Source: QUALCOMM Europe
Title: UE Timing related issues
Document for: Discussion & Action

Introduction

UE timing adjustment (slewing)

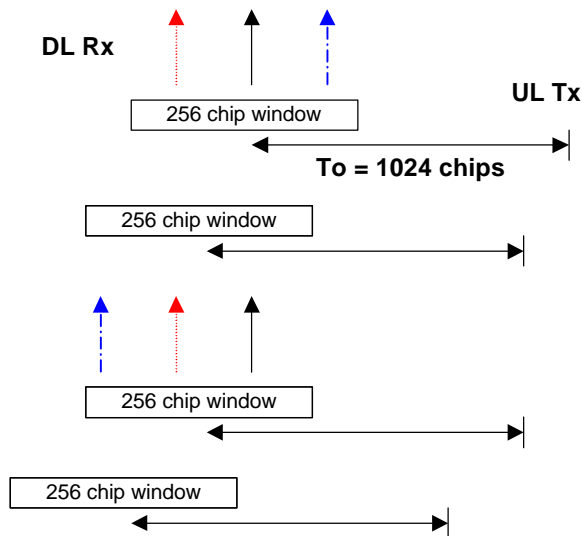
TS 25.133 defines a performance requirement which ensures that the UE adjusts its timing as the timing of the earliest cell drifts, the earliest received cell disappears or a new cell appears. The current text requires the UE to adjust its UL Tx timing so that it happens exactly (within 1.5 chip tolerance) 1024 chips after the earliest received DL path amongst cells in the active set. Although it seems to be the right thing to do (center of the “valid” range) this may lead to some problem in the asynchronous scenario.

Let's consider an active set with three cells each with a DL timing such that they are received 85 chips apart at the UE (see figure). Based on the requirement in TS 25.133, the UE would start adjusting its timing so that its transmit timing would happen 1024 chips after it receives cell 1. Assuming the "valid" windows is 256 chip wide, at some point cell 3 will go out of the "valid" window and the UE will report the event to the network which in turn will adjust cell 3 timing so that it appears in the "valid" windows again. The UE will then start to adjust its timing so that the transmit timing would be 1024 chips after it receives cell 3. Then cell 2 will go out of the window and so on and so forth. The UE would consequently continuously slew its timing. Although this is not a critical issue from signaling point of view (maximum slewing rate is $\frac{1}{4}$ chip per 200 ms which would result in one event every minute) it may still be preferable if this scenario is avoided. ***This can be achieved if the UE transmit timing happens 1024+128 chips after the first significant path is received. This would require a change to TS 25.133 and TS 25.211.***
